DEPARTMENT OF COMMUNITY DEVELOPMENT SERVICES

TO: The Urbana Plan Commission

SUBJECT: **Plan Case No. CW-2014-01:** 711 W. Western Ave., A request by the Central Illinois Mosque and Islamic Center for a Creekway Permit to construct a dormitory/gymnasium in the R-5, Medium High Density Multi-Family Residential Zoning District and the Boneyard Creek District.

Project: **Central Illinois Mosque & Islamic Center**
 Proposed CIMIC Annex Project
 711 W. Western Ave., Urbana, IL 61801

CAMPUS SITE PLAN CIMIC ANNEX

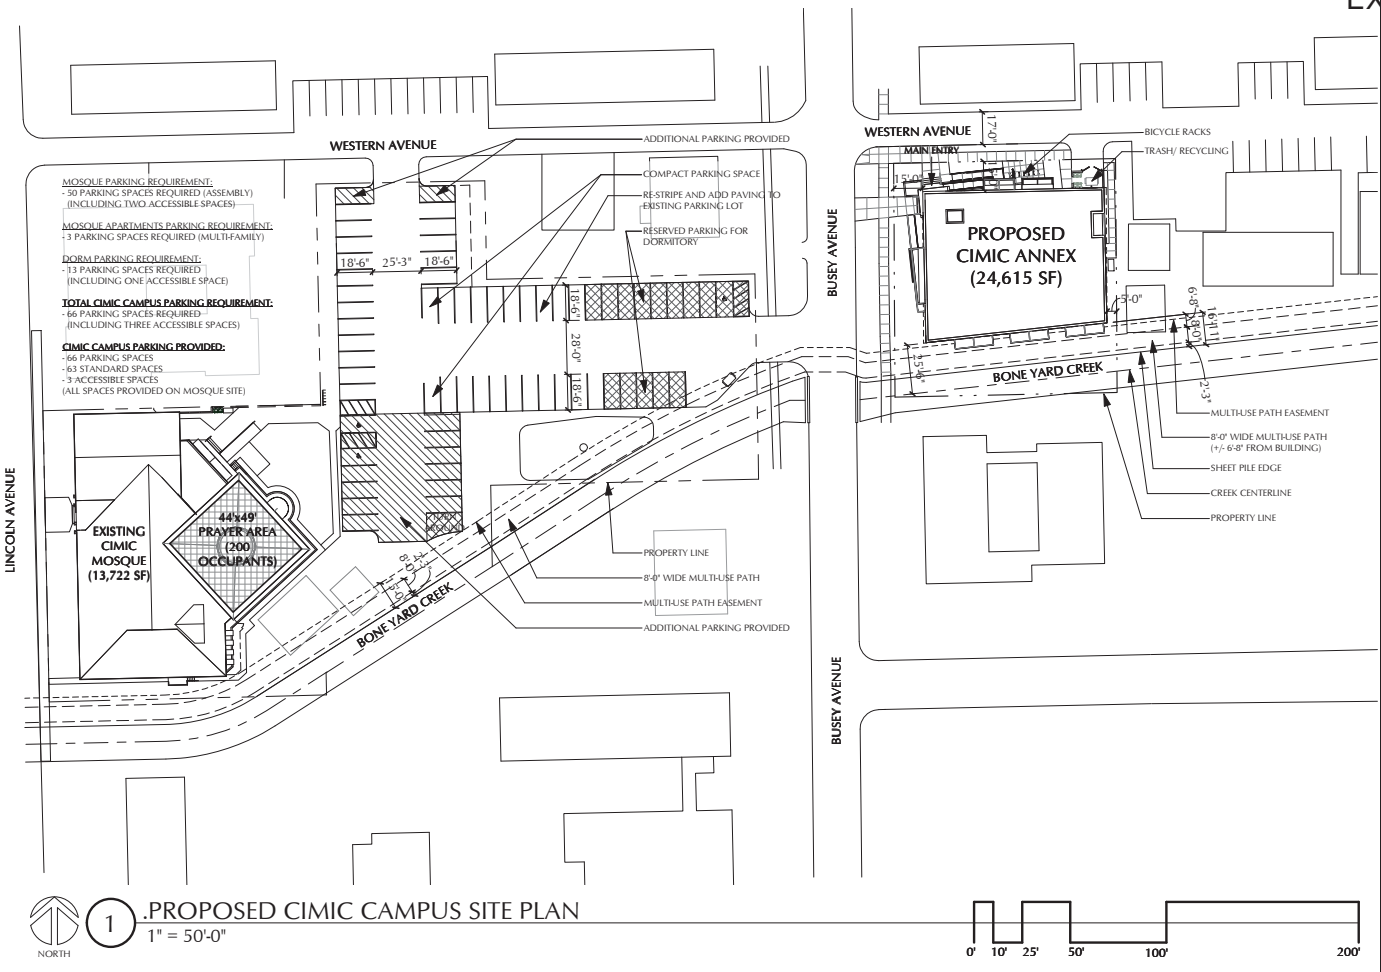
Mr. Gray noticed a small strip of property on the western edge of the parking lot that is not part of the parking area. He asked if this portion could be calculated in as open space. Ms. Wakefield replied that because it is not 15 feet deep, they did not show it as open space on Exhibit CWP-3. He also asked inquired about the area south of the parking lot that is cut out. Ms. Wakefield explained that the portion he is referring to is not part of the Mosque property. This particular portion actually belongs to the property owner across the Boneyard Creek.

Mr. Engstrom reviewed the Site Plan. He noted that all of the required parking will be at the Mosque Center, west of Busey Avenue.

1 PROPOSED LANDSCAPE PLAN
NTS

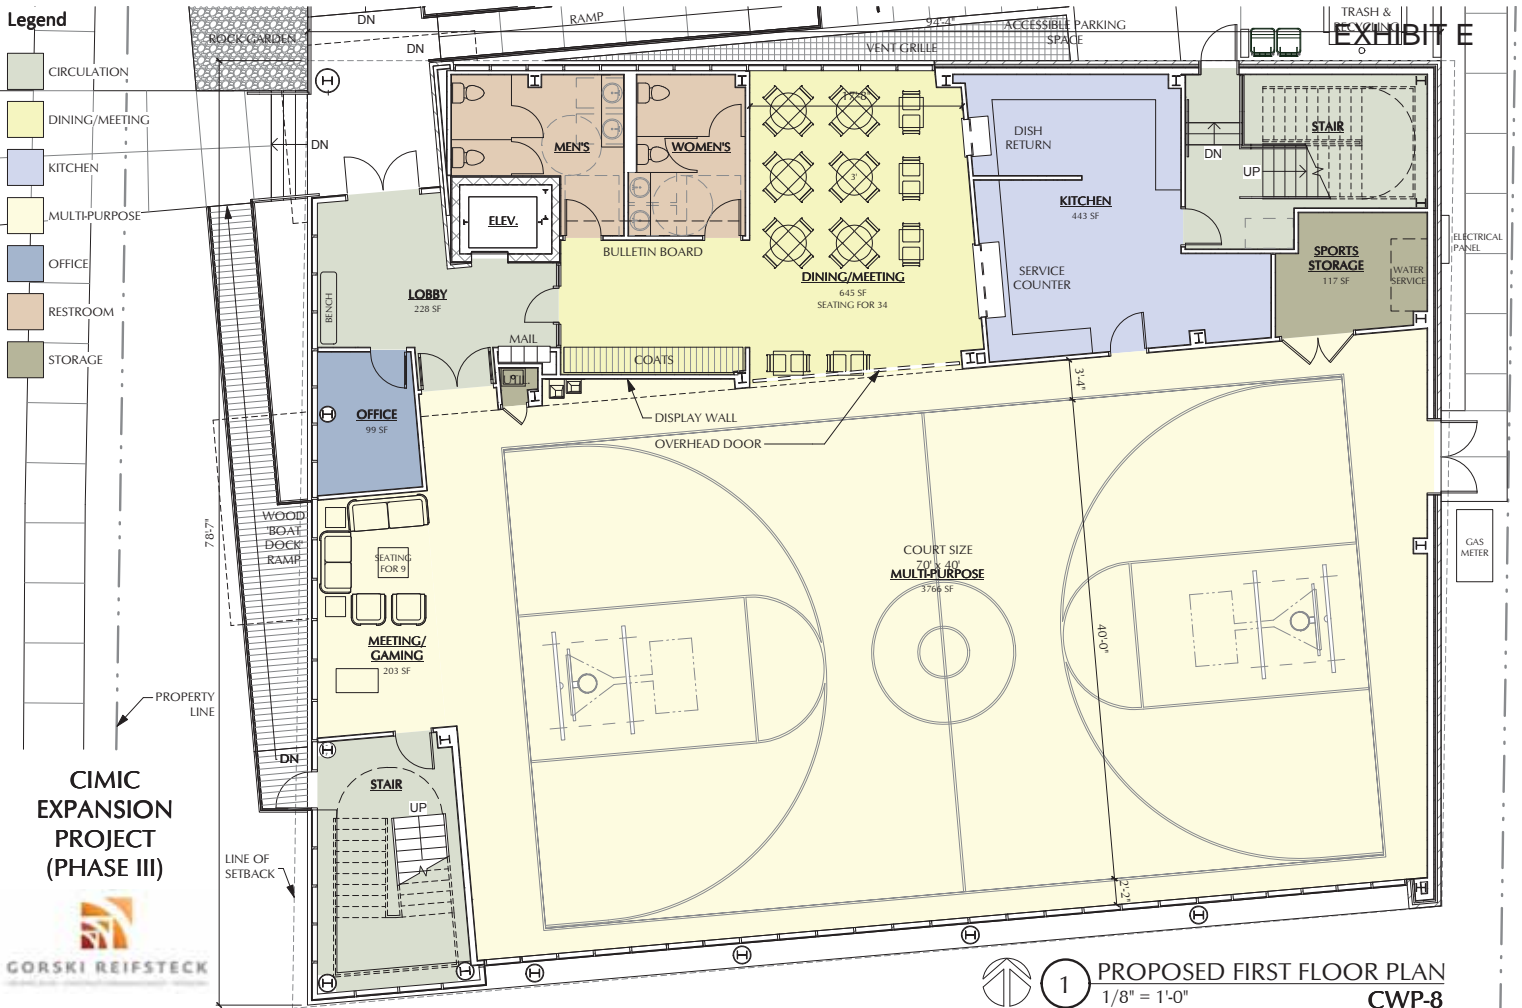
Ms. Tyler asked about a landscape plan. Mr. Engstrom stated that there is a copy in the packet of information for this meeting. He mentioned that installation of landscaping and open space along the Creekway as shown on the submitted Landscape Plan is one of the condition City staff recommends for approval.

Mr. Bullard asked for verification on any updated conditions recommended for approval of the proposed request. Mr. Engstrom stated that the only update would be to the landscape plan to state that the property owner is not responsible for the construction of the multi-use pathway.
